**13-IEP-1C**

# SCE's Comments on 2013 IEPR CEC Revised Forecast

IEPR Workshop  
October 1, 2013

## ➤ **Electric Load Forecast Update**

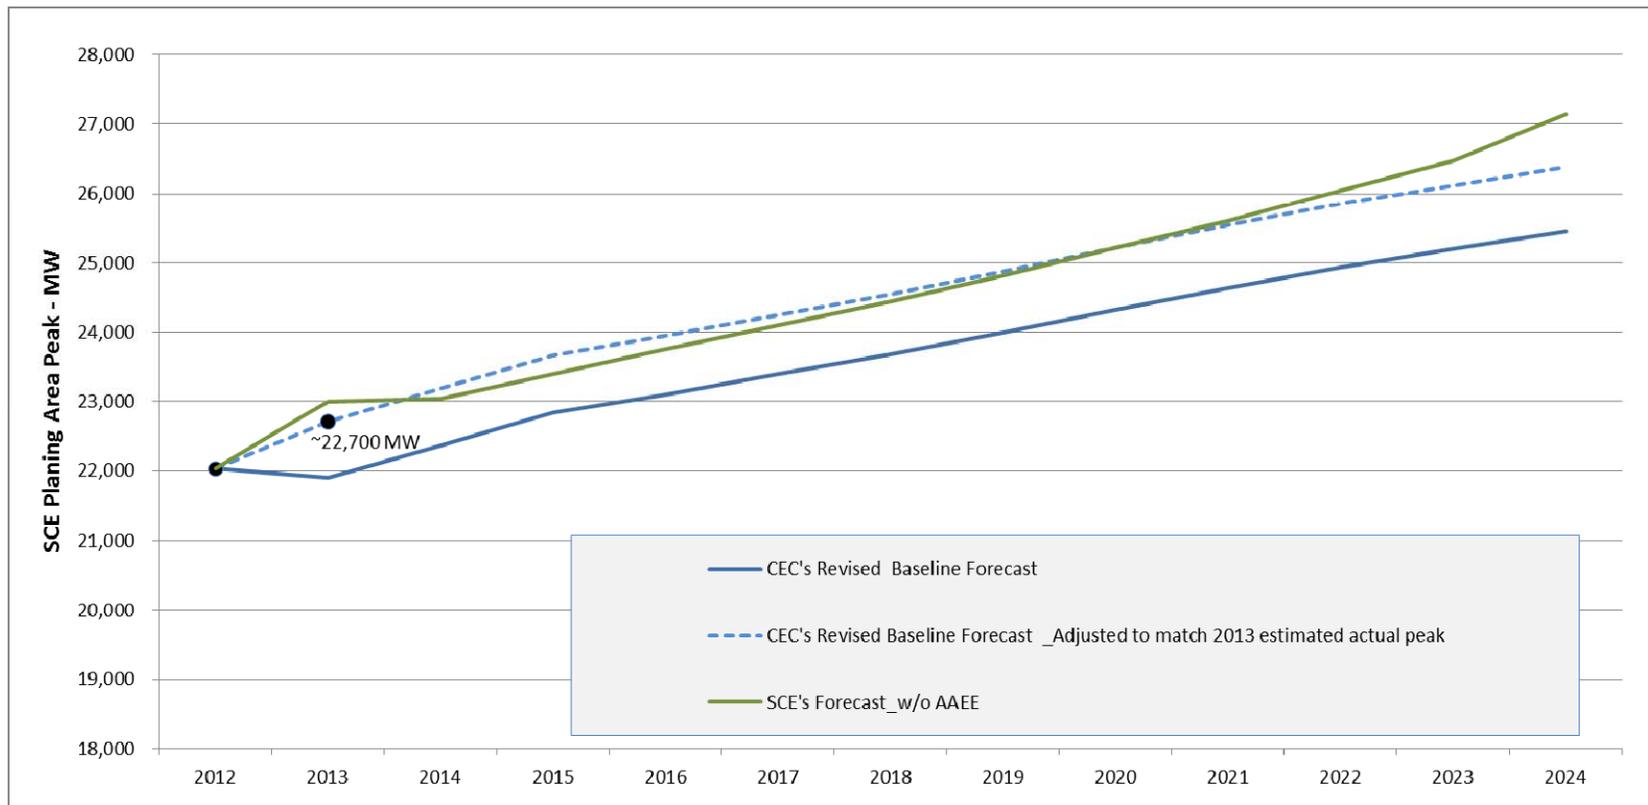
- Incorporation of updated EV load forecast
- Inclusion of other electrification load such as port electrification, existing light rail and subways
- Reflecting transportation electrification uncertainty through combining three scenario forecasts: a low-case, a mid-case, and a high-case forecast
